# Tarasima Apparels Limited (Extension)

1 April 2024

## 2. Observations:

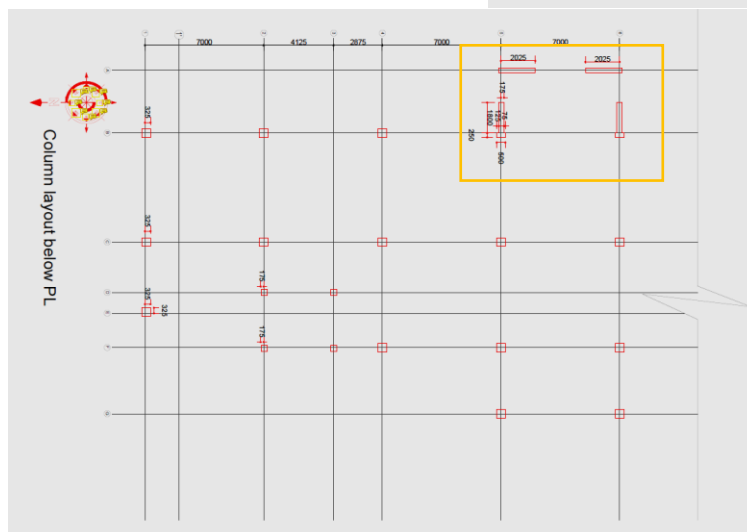
**Description:** Response modification co-efficient, R-value considered as 8 for IMRF, but no calculation/justification is provided for the consideration.

**Description:** The adequacy of the RC wall at the south stair cores was not incorporated in the provided design report. The building engineer is required to incorporate all types of adequacy checks in the design report and submit to the RSC for review.

**Observation 3:** Corrosion on exposed rebar. (Building-J)

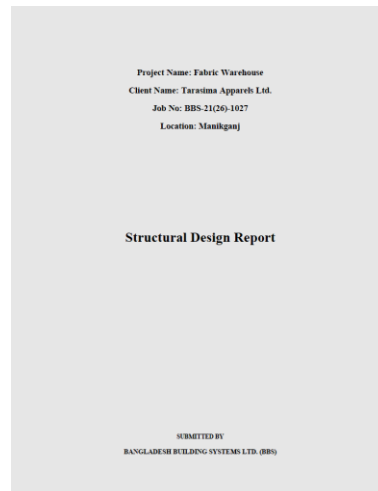
**Description:** Corrosion was observed on the exposed rebar. The building engineer is required to remove rust and apply anti-corrosive paint on exposed rebars.
